Document Number: SPIRE-RAL-NOT-001469

Title: Rework of Ground Test Harnesses for Grounding Scheme Compliance

Date: 18 December 2002

Figure 1 - Diagrammatic representation of rework.

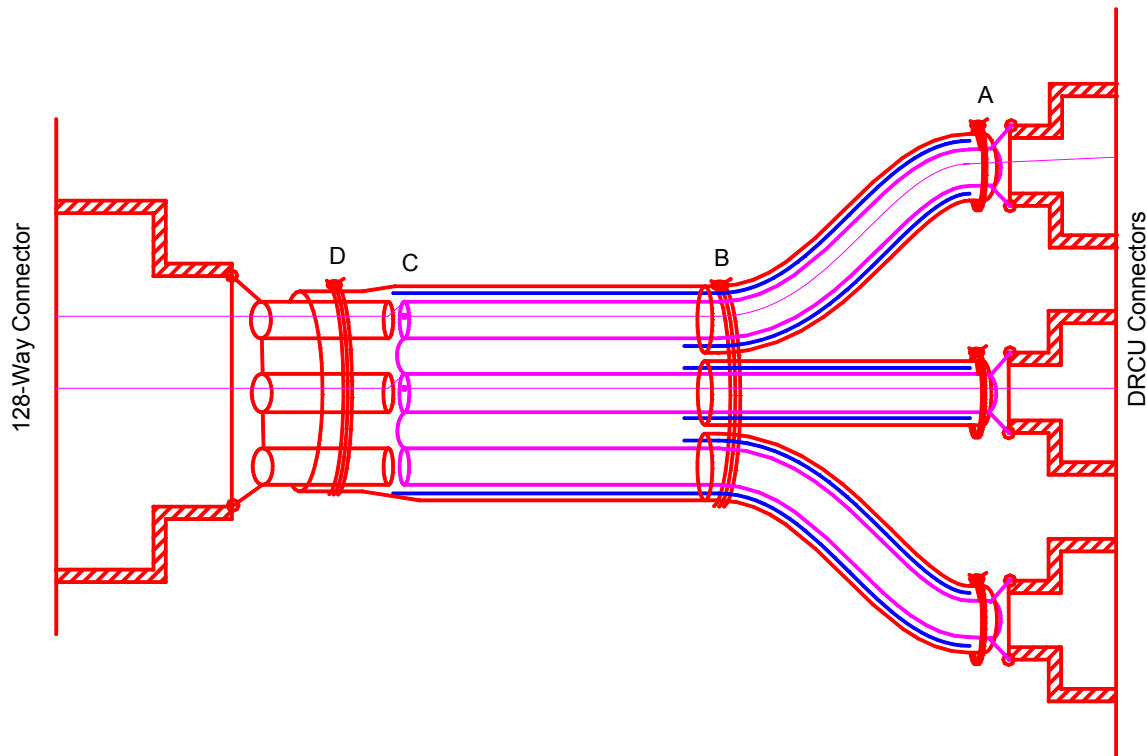
- (1) **Tail lengths:** The length of each individual tail is to be greater than 300mm. (Distance A ⇒ B)
- (2) **Insulation wrapping** (indicated in Blue): Between the DRCU tails (point A) and point C near the 128-Way connector, a flexible insulating tape is to be wound around the existing shield braid (Mauve). This insulation does not need to cover each individual tail between B and C but could be wrapped around the entire group of tails as drawn. The insulation guarantees electrical isolation between the existing braids (Mauve) and the overshield (Red) at all points except Point A where they are electrically joined.

- (3) **Existing braid to FPU Faraday Shield Conductors:** At approximately 50mm from the back of the 128-Way connector (Point C), the existing braided shield is cut. Any tail that has a conductor identified as “FPU Faraday Shield Link” in the SPIRE Harness Definition Doc - Issue 1.0 has the conductor broken at Point C. The ends of these conductors connected to the DRCU (which is now redundant) are left un-terminated with insulation over any bare conductor. The ends of the FPU Faraday Shield Links passing to the 128-Way connector are

joined to the existing braids that terminate at the DRCU end. The existing shield over each of the tails are to be daisy chained together at this point as shown.

- (4) **Overshield:** Between points A and D, a >80% optical coverage wrapped braid will act as the bundle overshield. At points A and D, the overshield will make a 360° connection to the existing overshield being the closest we have to a connector backshell.
